Customer Satisfaction Program 25B34

**TO:** All U.S. Ford and Lincoln Dealers  
**SUBJECT:** **Customer Satisfaction Program 25B34**  
Certain 2025 Model Year Ford Maverick Lobo Vehicles  
Cooling Fan and Radiator Replacement

## CERTAIN 2025 MODEL YEAR MAVERICK LOBO VEHICLES — COOLING FAN AND RADIATOR REPLACEMENT

FIGURE 1

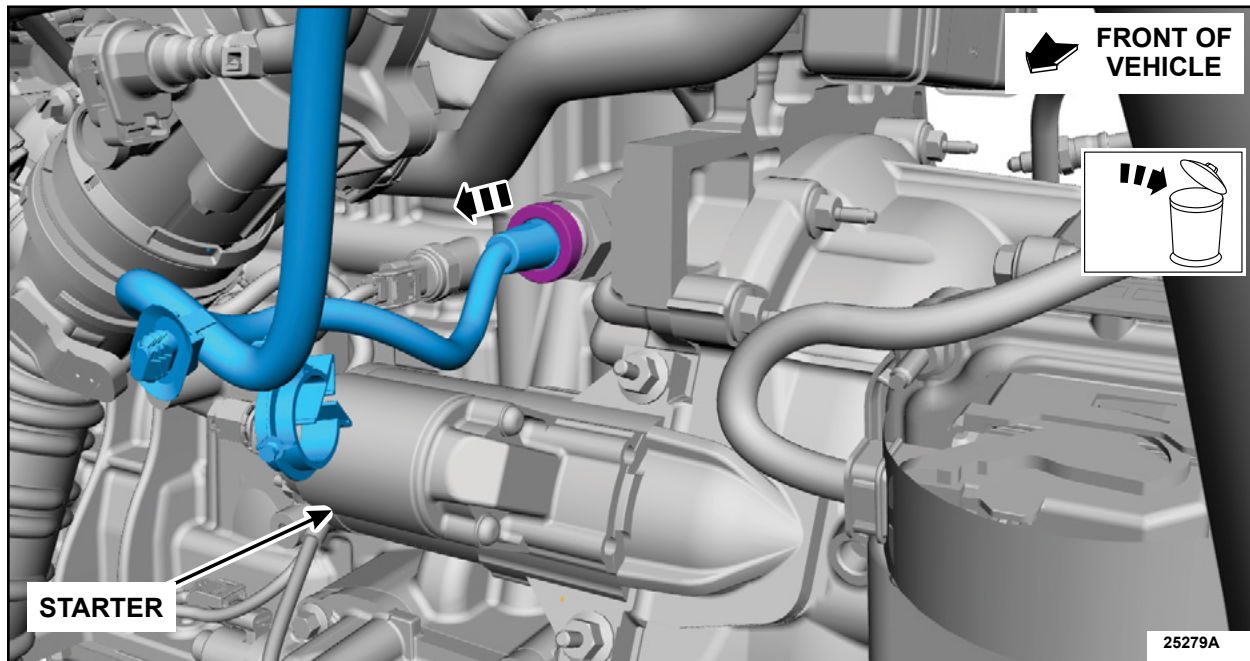
2. If equipped, remove and discard the engine block heater cord located above the starter. See Figure 1.

FIGURE 2

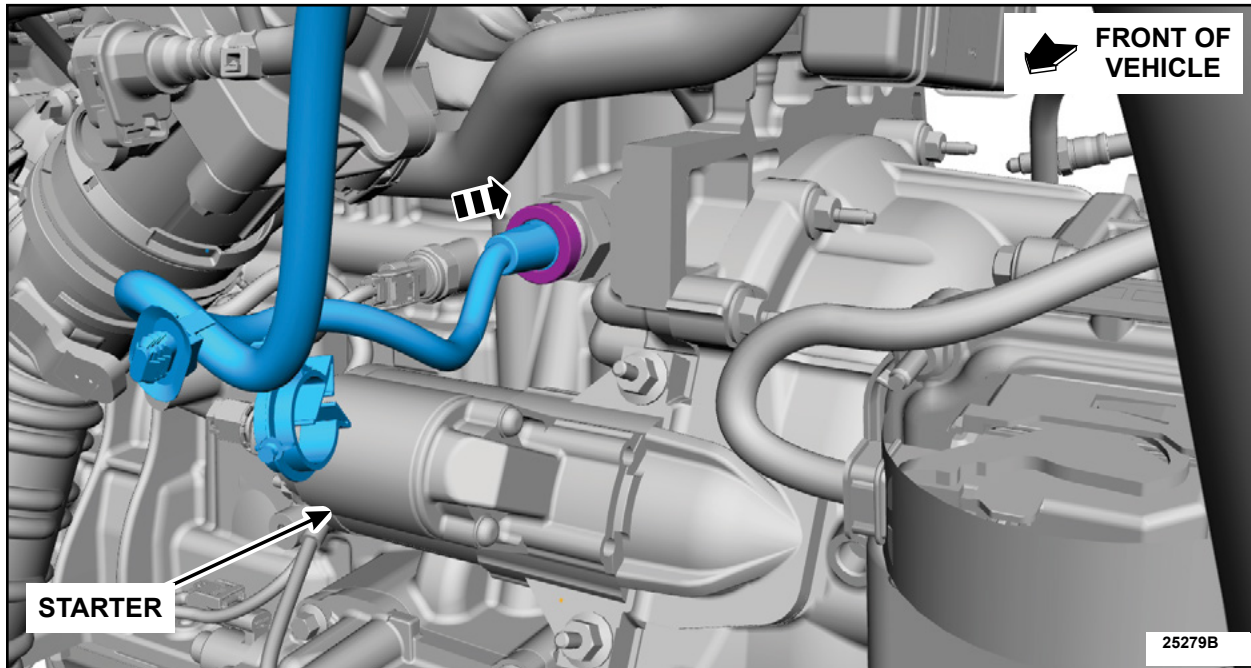
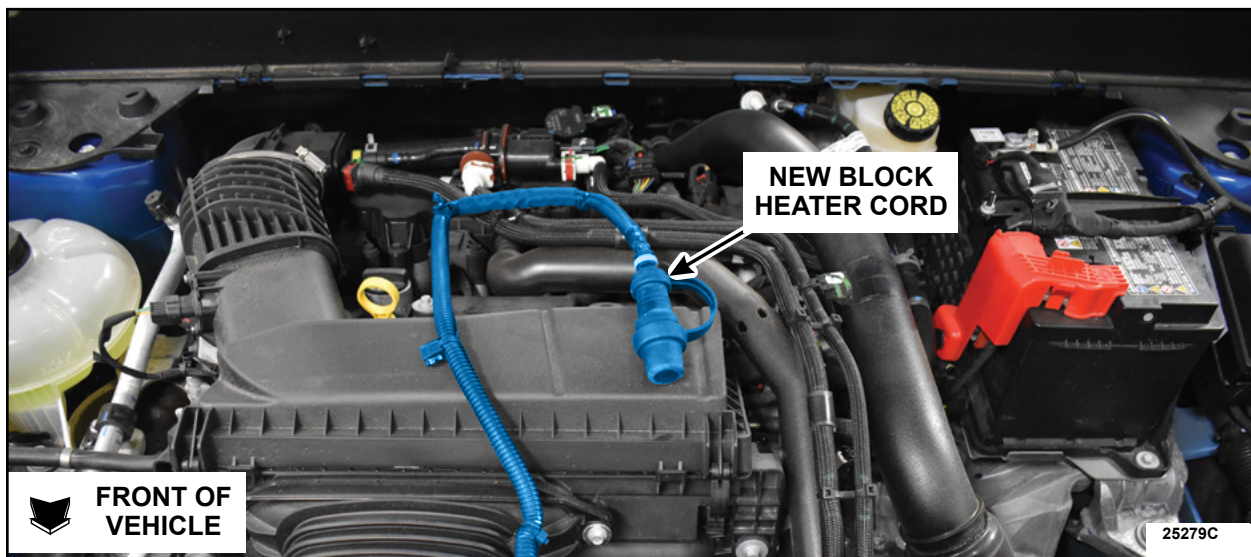
3. If equipped, plug in the *new* block heater cord and position it over the top of the engine.  
See Figures 2 and 3.

**FIGURE 4**

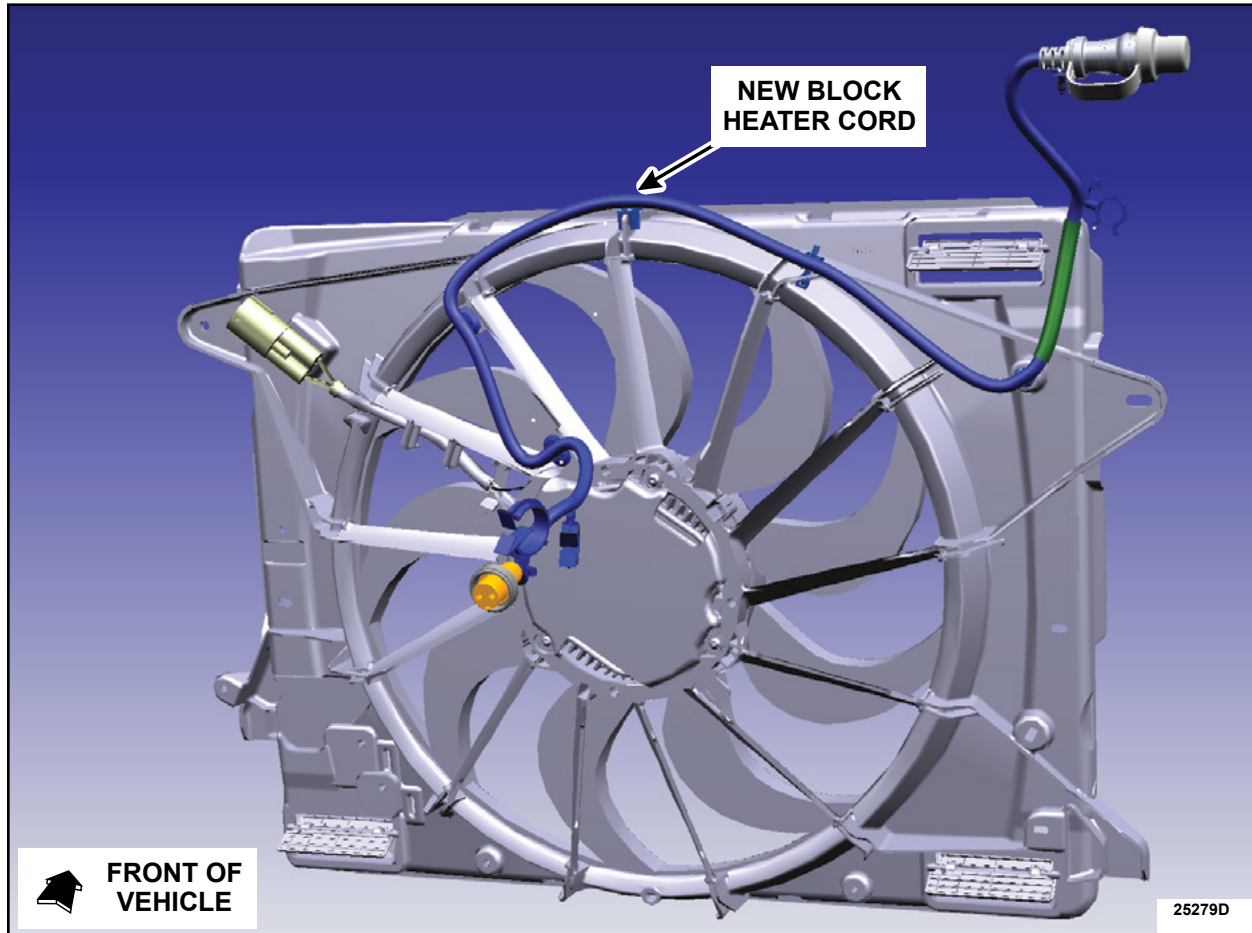
5. If equipped, route and secure the *new* block heater cord to the cooling fan shroud. See Figure 4.

**NOTE:** Cooling fan shroud and block heater cord shown outside of the vehicle for clarity.
